**Subject:** Re: MC TP/SS Library Tree Removal  
**Date:** Thursday, June 8, 2023 at 2:43:56 PM Eastern Daylight Time  
**From:** Marty Frye  
**To:** Streagle, Andrew  
**CC:** Peck, Stephen, urbanforestmanager@takomaparkmd.gov  
**Attachments:** image002.png, image001.png

The tree in question is tree TM, 12" flowering cherry. Can this be a field change if both of you concur? Or do we need to update any plan sheets? The College is going to put a new tree back in this general location as well, at the end of the project. Likely a bit further away from the building!

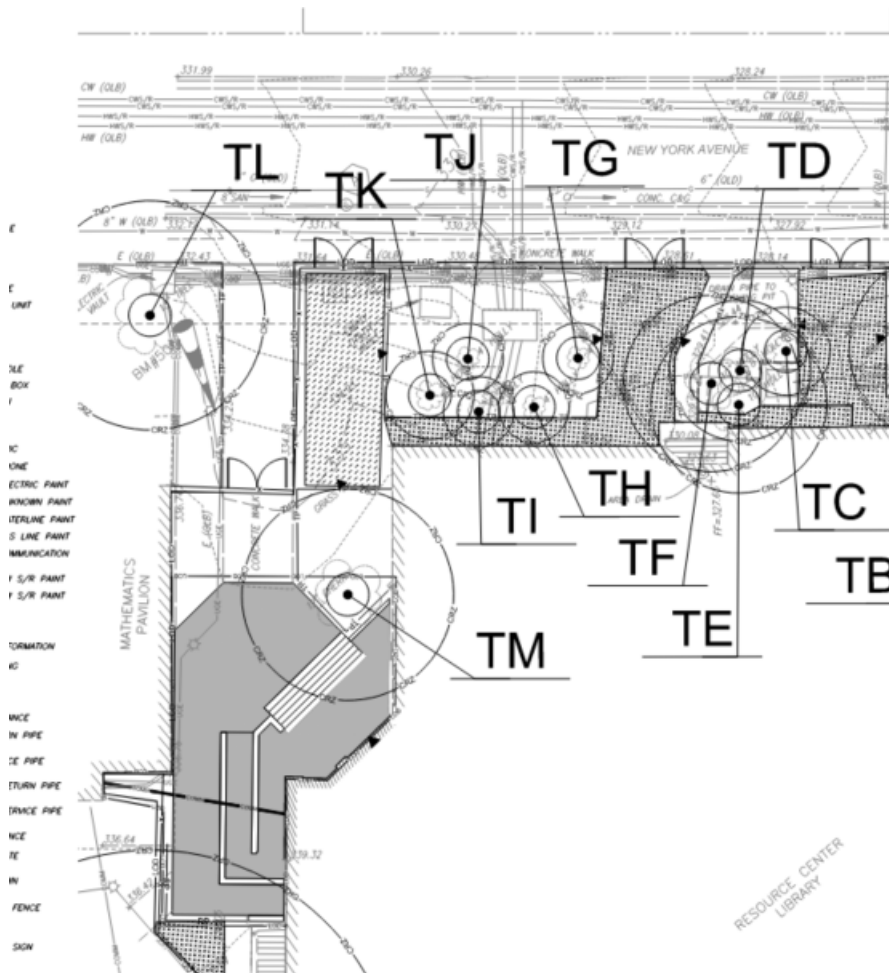
The College is looking to remove one additional tree that we had anticipated on keeping, see image below. I gather that the footings for the proposed structure improvements (and the associated excavation) are more extensive than we were aware of.

Yes 1:1 is acceptable here. Thanks.

I am working with MC folks to make a selection for the replacement tree, assuming it is a 1:1, tree for tree replacement here. Probably 2" cal. native (hopefully) ornamental, like Amelanchier or Cercis. We just wanted to confirm that you were on board with this before we made a final selection.

Thanks for the heads up here. This email correspondence will suffice to document the change. Are you able to provide any plan documentation of the replacemeting planting that will be used to account for the removal of this tree?
